**STATE OF NEW HAMPSHIRE  
SITE EVALUATION COMMITTEE**

**Docket No. 2014-03**

**Re: Motion of Granite Reliable Power, LLC to Amend a Certificate of Site and Facility  
with Request for Expedited Relief**

**DECISION GRANTING THE MOTION OF GRANITE RELIABLE POWER, LLC  
TO AMEND A CERTIFICATE OF SITE AND FACILITY**

**Attachment 2 – Restoration Drawing No.'s R299, R300, R301, R302, R303  
and R304**

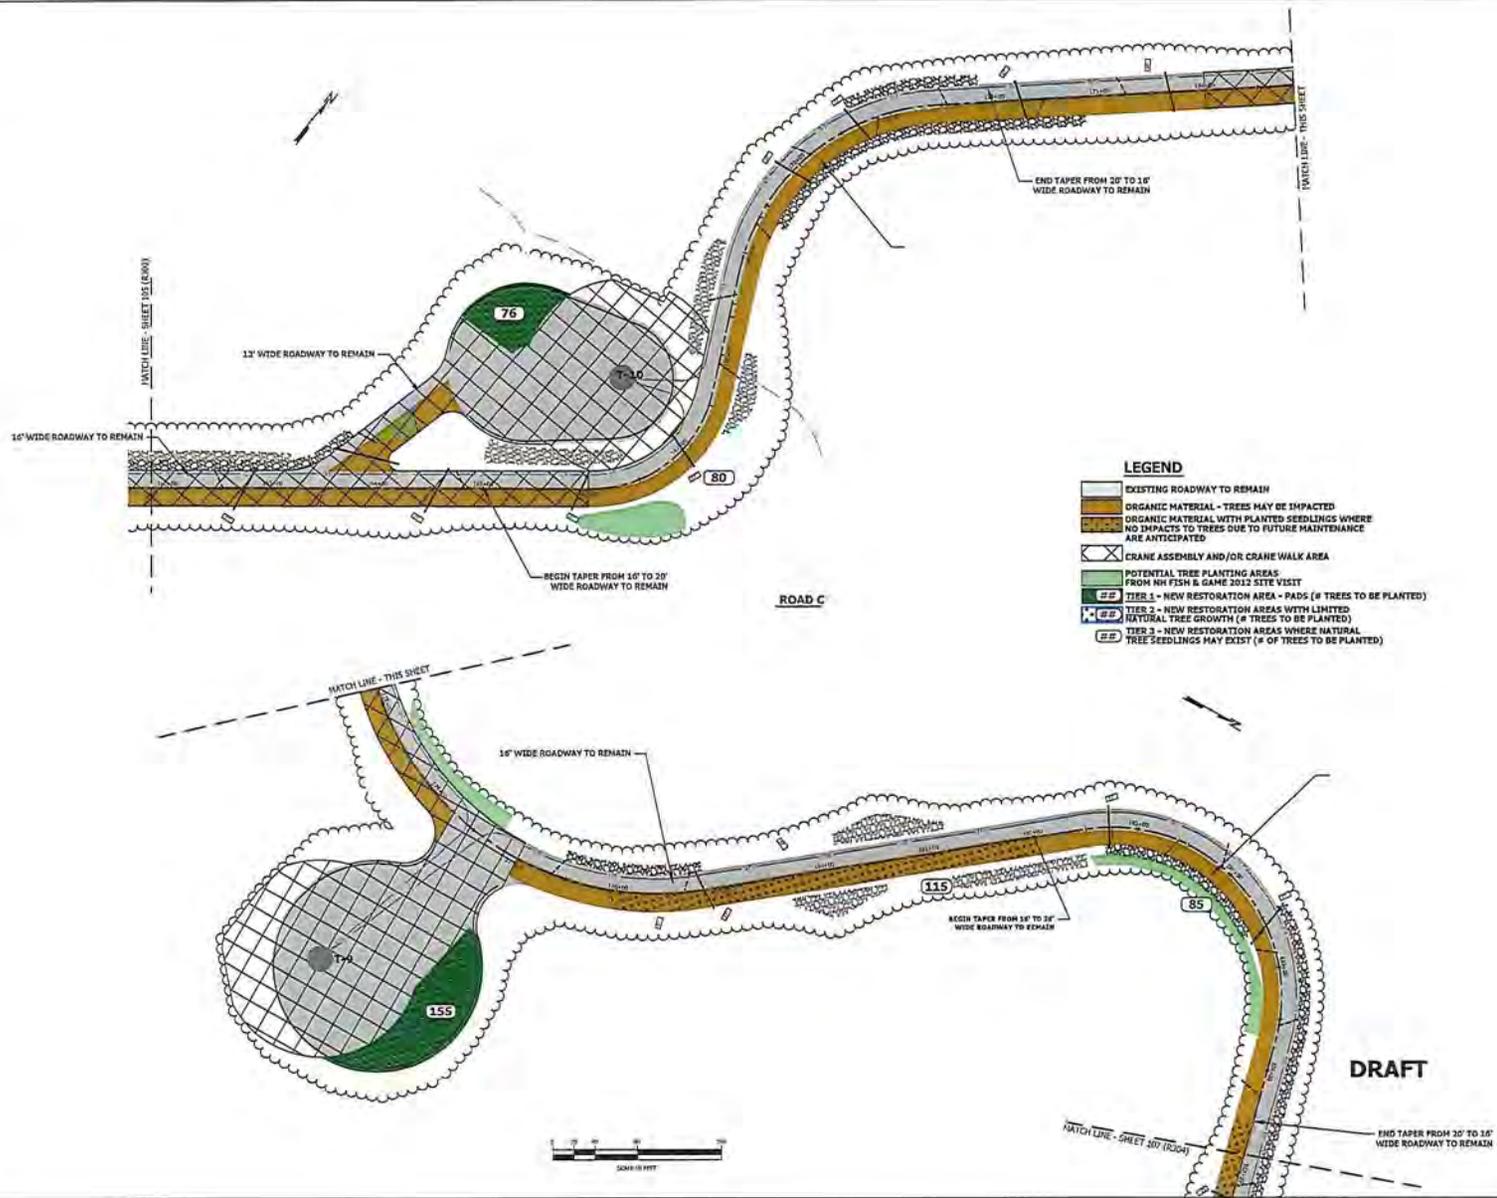
1. Surface a narrower portion of the 34-foot roadway with organic material consisting of forest duff, soil, and stump grindings and re-vegetate with planted seedlings. Generally, this will result in a 16-foot wide roadway surface with planted trees. However, at certain corners, roadway surfaces will be wider to accommodate the turning movements of larger vehicles needed for wind turbine maintenance. This vegetative treatment can be seen on the drawings (R299, R300, R301, R302, R303 and R304) in Attachment 2. No trees will be planted within adjacent ditches.

Seedlings will not be planted in water control structures (such as rock-lined ditches), and above the underground collection lines. The drawings showing the proposed planting areas are contained in Attachment 2 (R299, R300, R301, R302, R303, and R304).

**Attachment 3- RMT Sheet No.C599 (amended and renamed R599)**

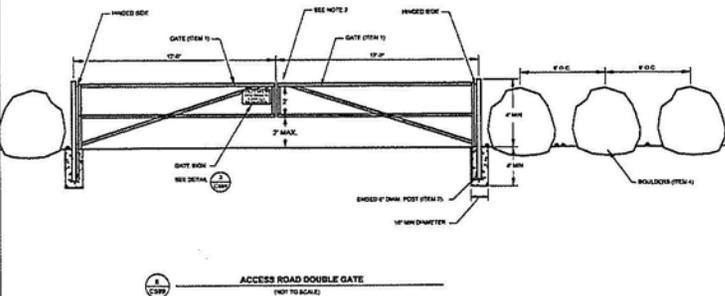
- a. **Grading** - The original permit drawing entitled *High Elevation Access (>2,700 feet) Road Restoration Details* (RMT Sheet No. C599) has been modified to reflect NHF&G's and Granite's proposed changes described above. The revised plan (R599 contained in Attachment 3) shows a cross-sectional view of a typical access road during the construction phase and as restored following construction. Forest duff, soil, and ground-up stumps removed for the construction phase will be stockpiled, to the

- REVISIONS**
1. MODIFIED ROADWAY WIDTH ON TYPICAL ROAD CROSS SECTION - RESTORATION.
  2. CALLED OUT SEEDLING ZONE ON TYPICAL ROAD CROSS SECTION - RESTORATION.
  3. REMOVED REFERENCES TO HIGH ELEVATION GRASS SEED AND PLY MULCH.
